RESPONSE TO SUBMISSIONS

RURAL SUBDIVISION

PRESTON BEACH ROAD, LAKE CLIFTON

PUBLIC ENVIRONMENTAL REVIEW

Proposal Footprint

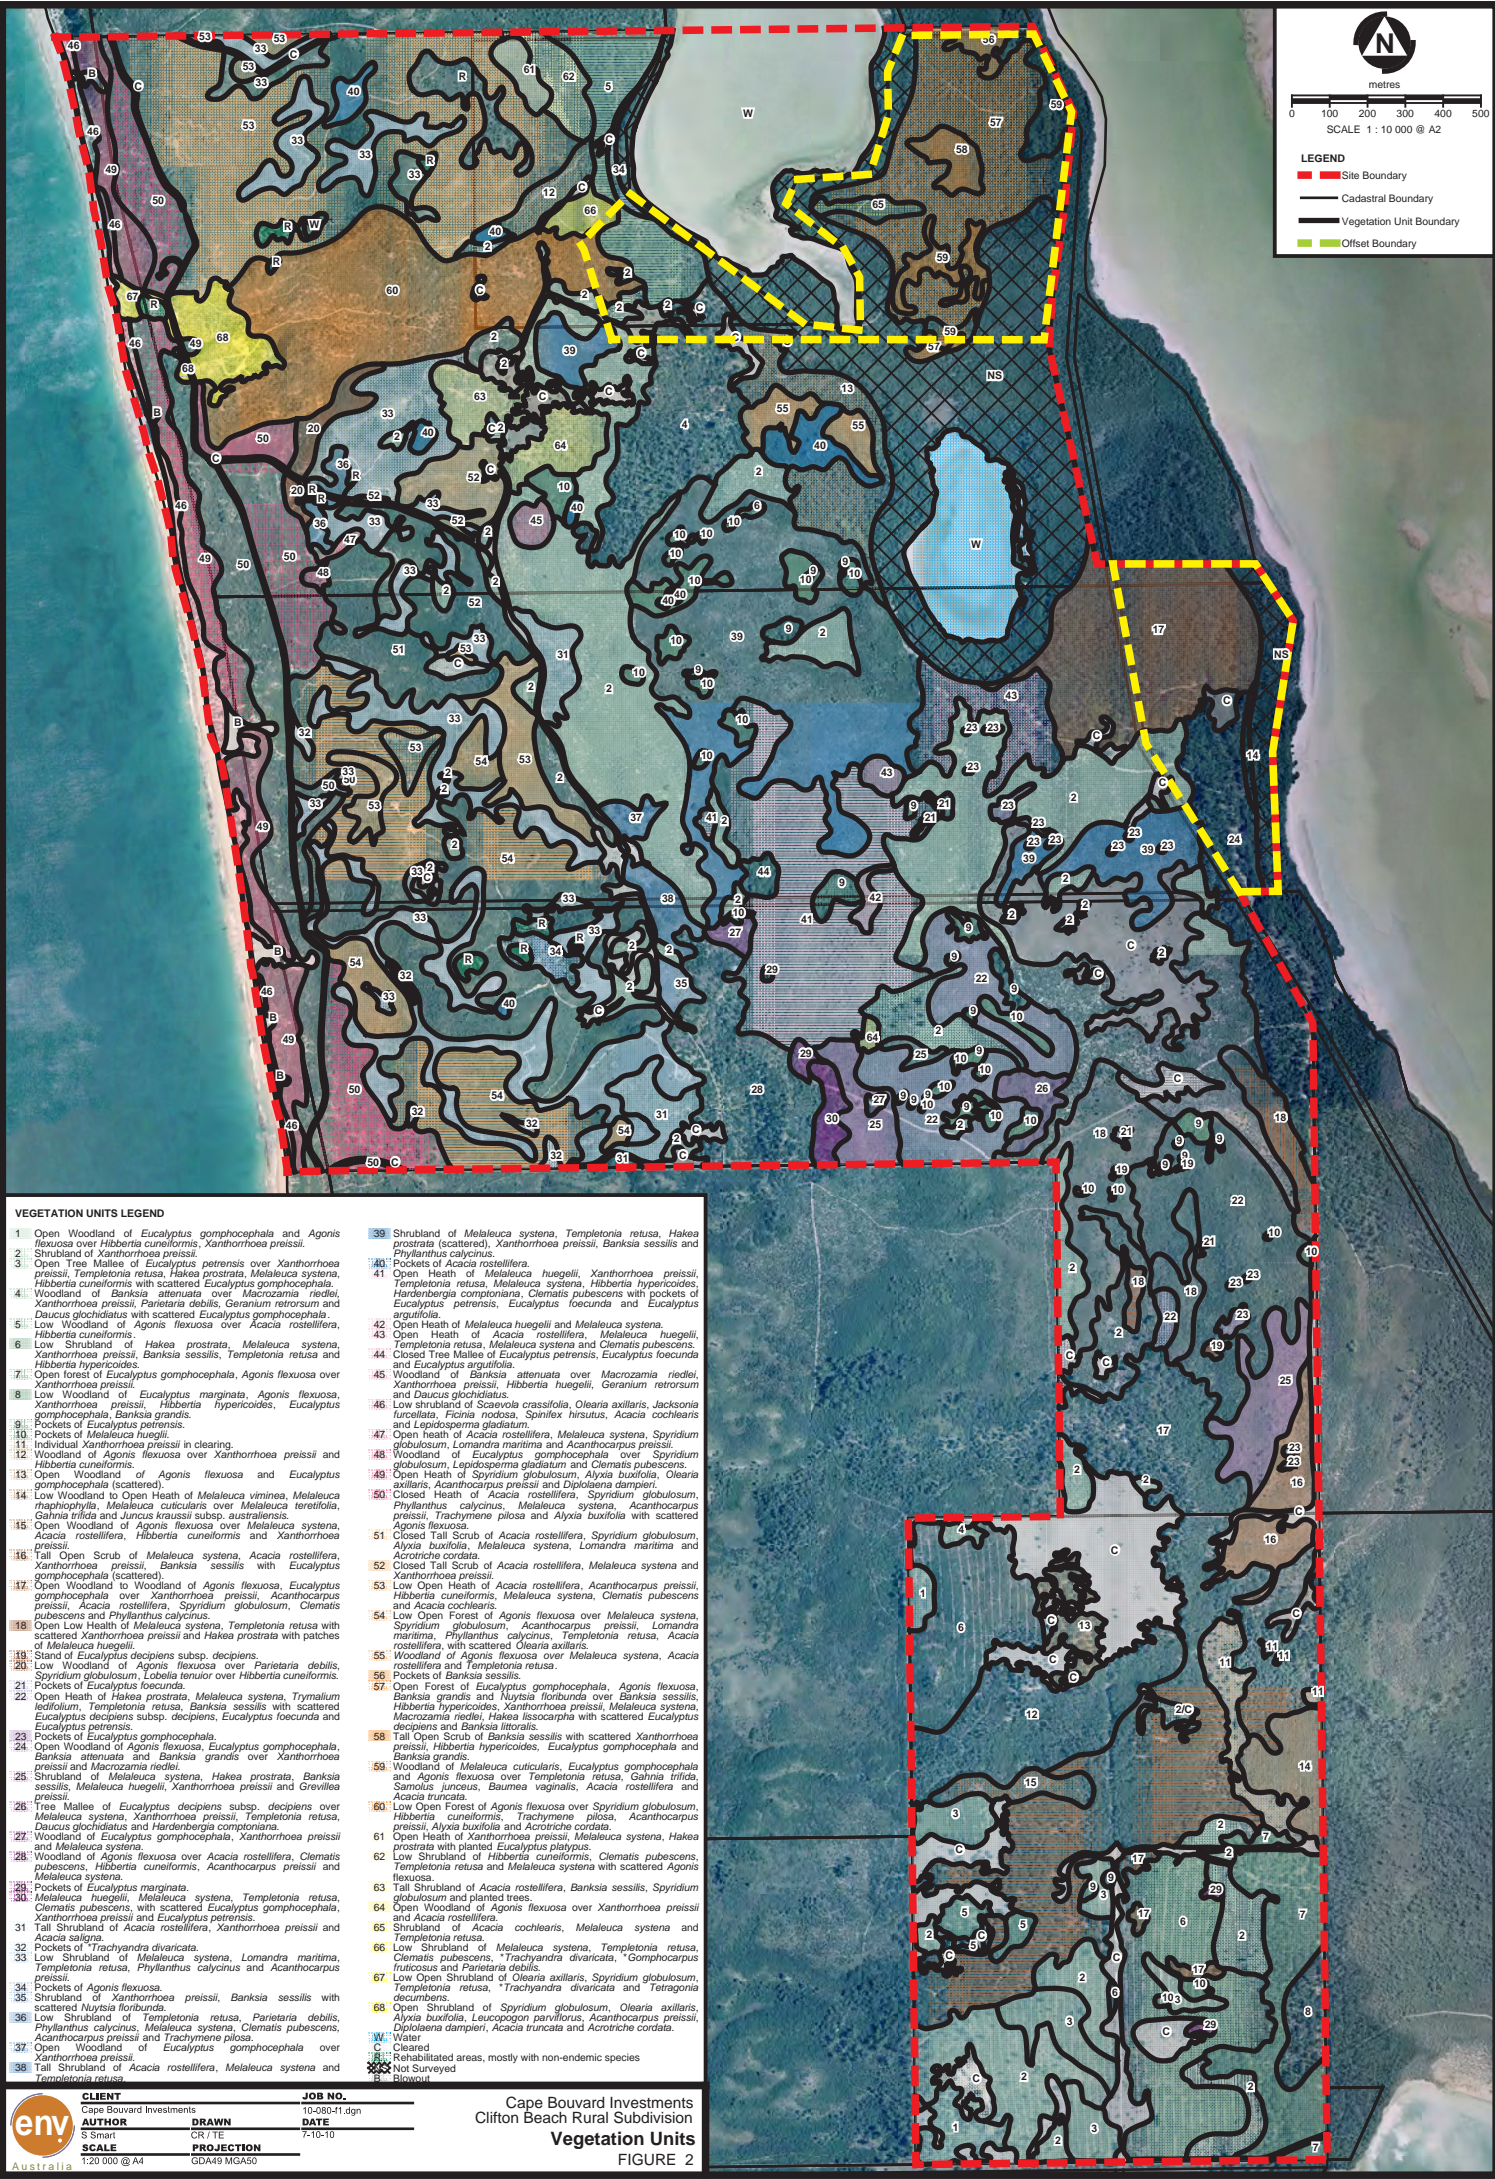
“The Key Characteristics Table should provide total footprint sizes for all subdivision elements, i.e. roads, driveways, building envelopes, fire protection zones around building envelopes, fencing, driveways and firebreaks. A separate table should indicate the amount of clearing required for all sub-division elements making reference to the critical asset, vegetation type or community and the condition of the community that is to be cleared. Details of the calculations, i.e. widths of roads, location of turnarounds etc., should also be provided for clarity. “

All firebreaks adjacent to wetlands are shown in Figure 1. Currently, there are a number of existing firebreaks within the wetland buffer areas, in particular to Boundary Lake to the north (Figure 1). These firebreaks will be maintained post development to minimise excessive clearing and increase fragmentation throughout the site. No additional clearing will be undertaken to build fences as they will be located on the boundary of a firebreak. Fences will protect all wetlands from access. **No additional clearing in wetland buffers is proposed.**

The key characteristics of the subdivision are articulated in Table 1 below and shown spatially as Figure 1.

The location of building envelopes has been provided as part of this response to submissions. Building envelopes have been located outside of environmentally sensitive areas including Threatened Ecological Communities (TECs), wetlands, wetland buffers, and the groundwater protection area as shown on Figure 1.

Strategic firebreaks only will be constructed on the perimeter of the strata scheme with internal firebreaks following roads rather than boundaries (Figure 1). The firebreaks will be hard coated with limestone to prevent erosion. The by laws can stipulate maintenance responsibilities and these can be regulated by the Body Corporate.

Figure 26: Scenario 8 Groundwater Impact

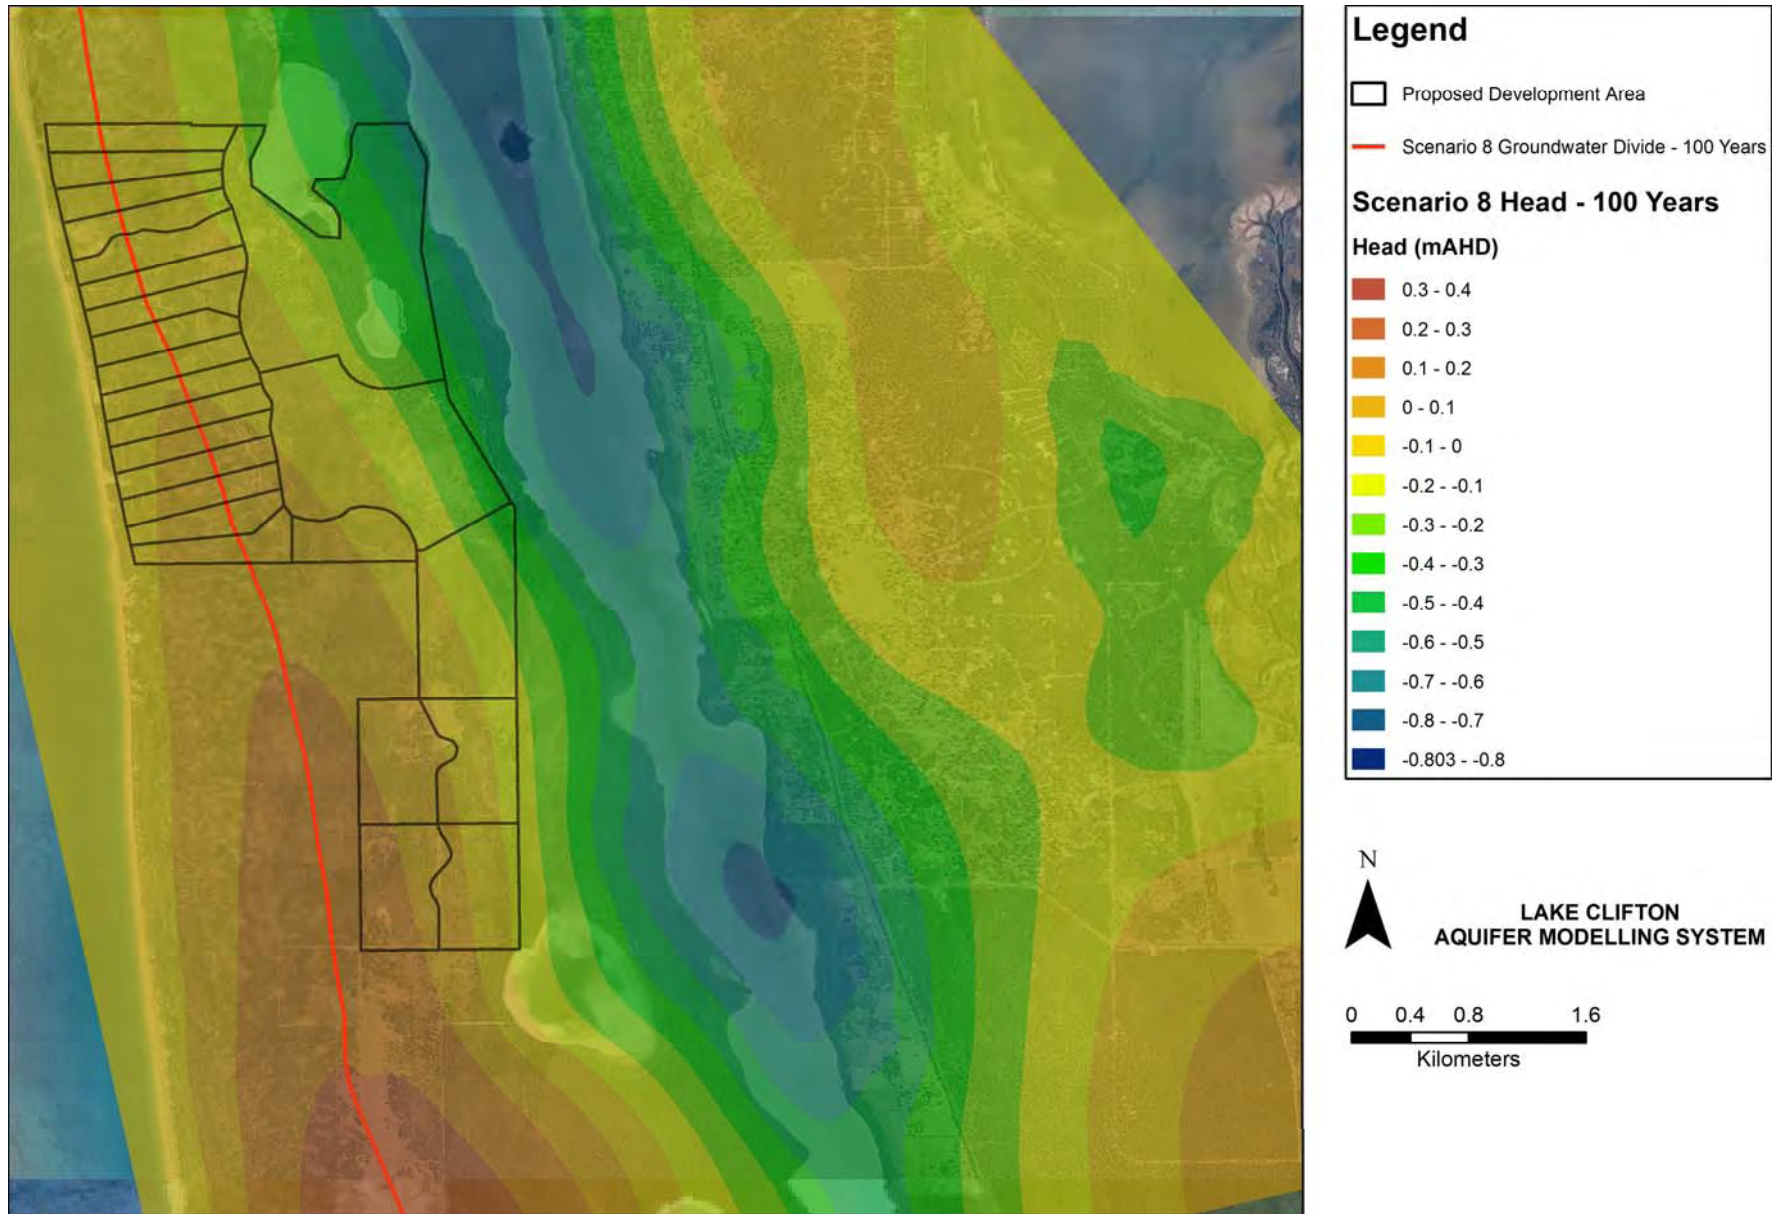
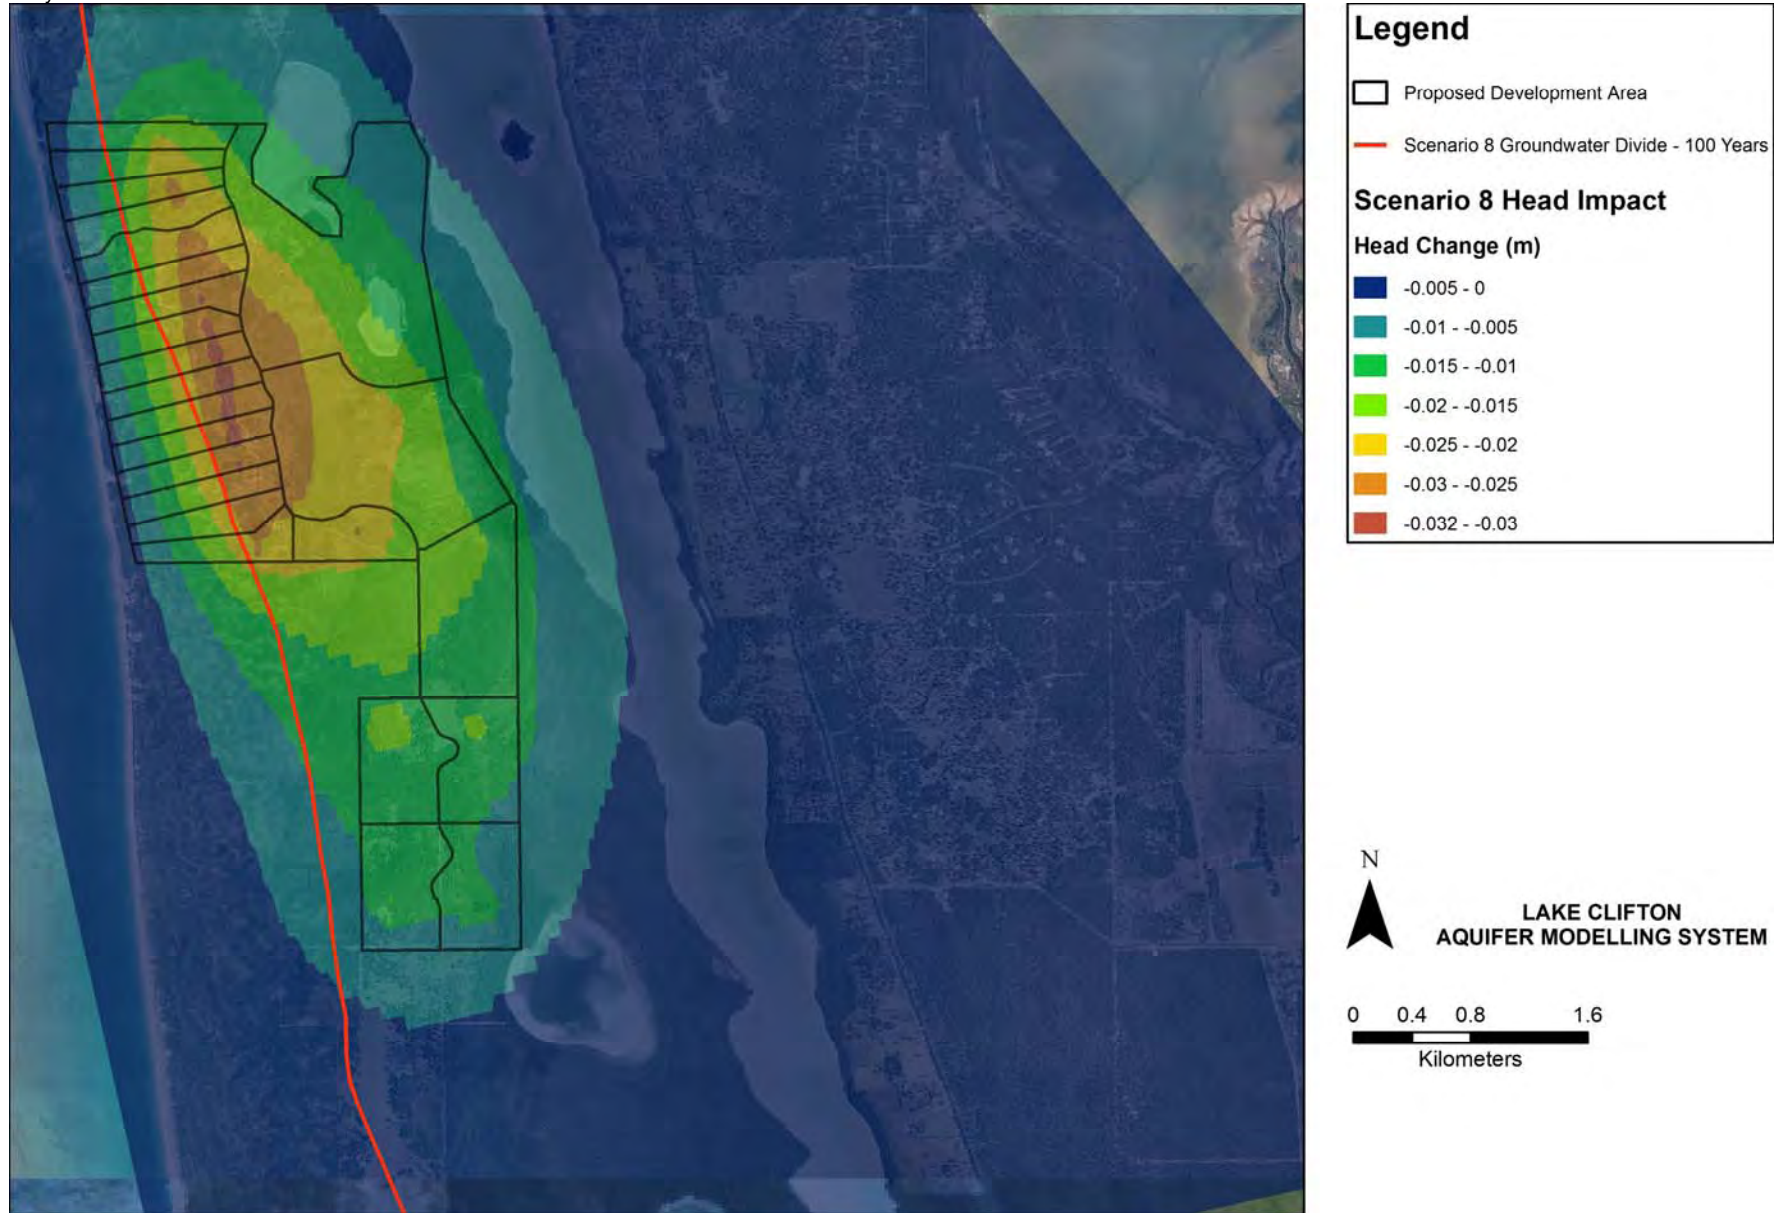
“Scenarios investigated are not informative. Scenario modeling should include investigating potential impacts to the lake under the influences of climate change as well as various scenarios relating to development including increased abstraction, increased discharge via stormwater and effluent systems. “

Figure 25 (Appendix C) shows the groundwater level at the end of the 100 year simulation period and the groundwater divide. Figure 26 (Appendix C) shows the groundwater level impact due to increased abstraction after 100 years of simulation. The only notable feature is the cone of depression associated with the 4500 kL/annum abstraction from each lot. The drawdown due to this abstraction is a maximum of 0.03 m.
